AGENDA
ATHENS CITY COUNCIL
MONDAY, SEPTEMBER 11, 2023
7:00 PM
e-mail: dwalker@ci.athens.oh.us
Streaming is available at www.ci.athens.oh.us/video

Case #23-02 Homestead Court and Broadmoor Planned Unit Development

University Estates Planned Unit Development (PUD) Homestead Court and Broadmoor

**City of Athens Engineering and Public Works
Private Development Plan Review Response Summary**

C-13

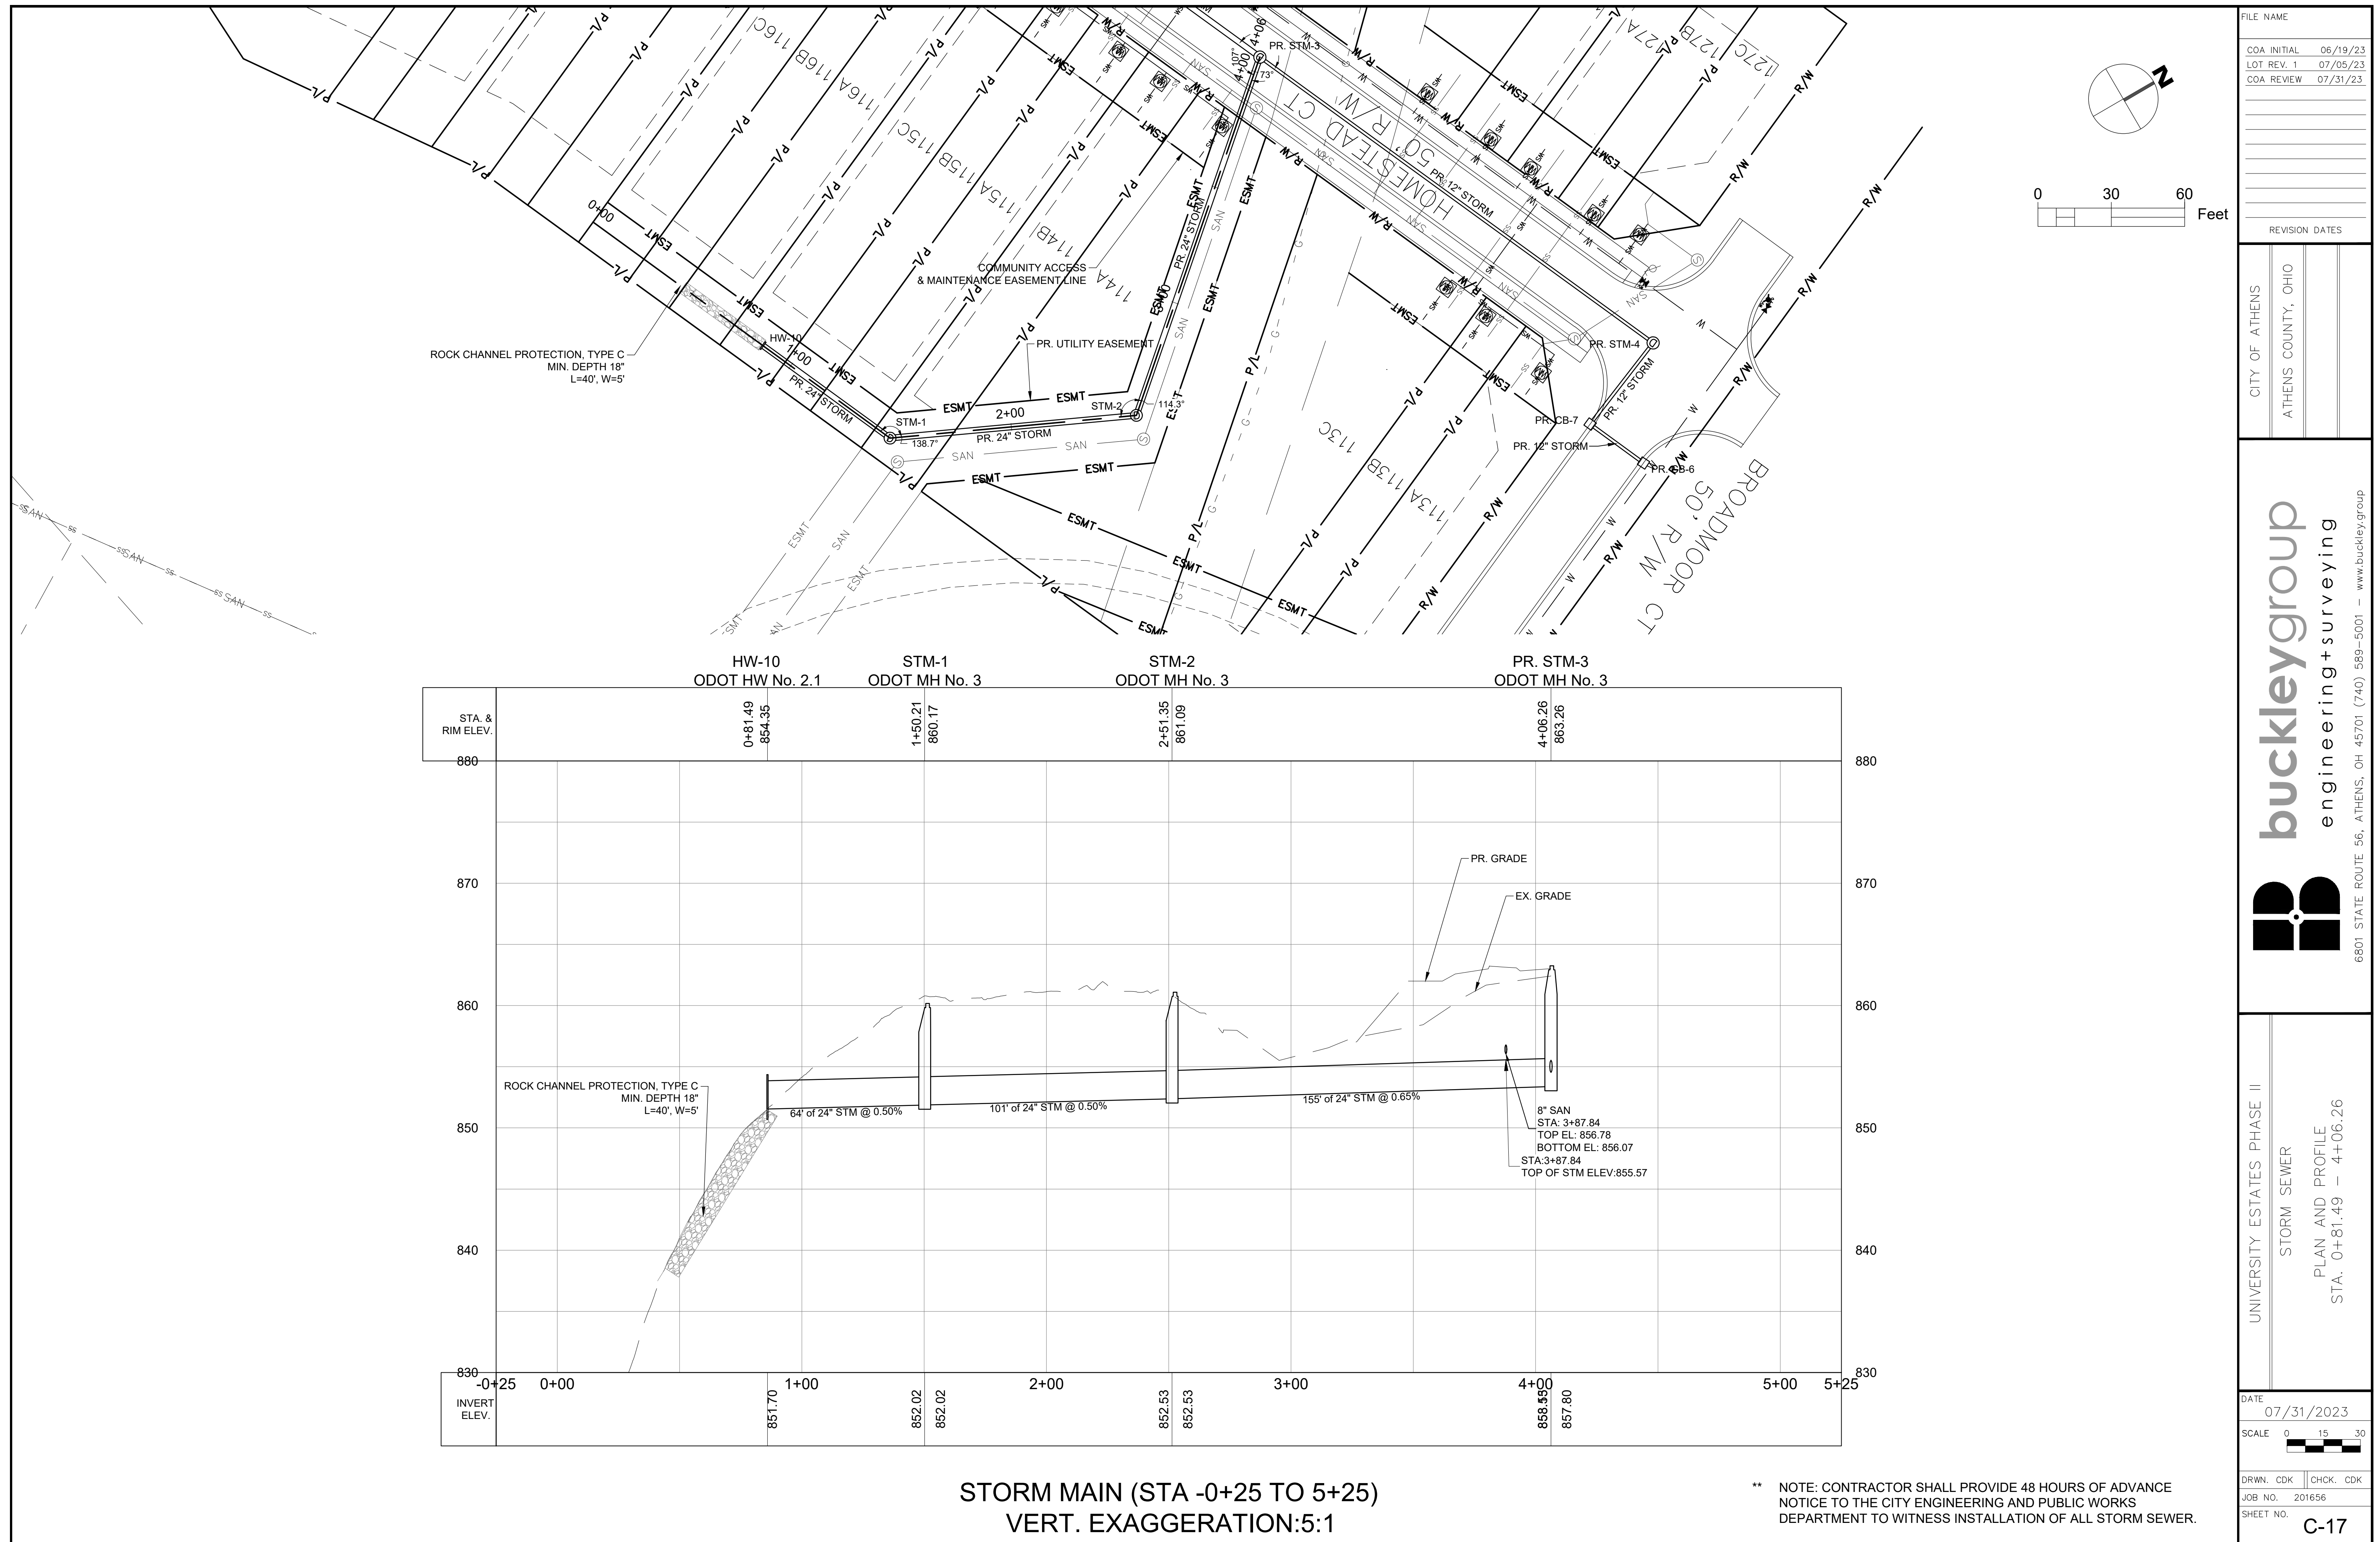
1. Please review the storm outfall on Sheet C-13. There appears to be a steep grade below the storm outlet.
Vertical Exaggeration is 5:1 on the profile. Discharge point is on the opposite side of the ravine of the Homestead Ct development. This is the only place to discharge within the boundaries of the owner's property and maintain space for construction of the density of structures required for this project.
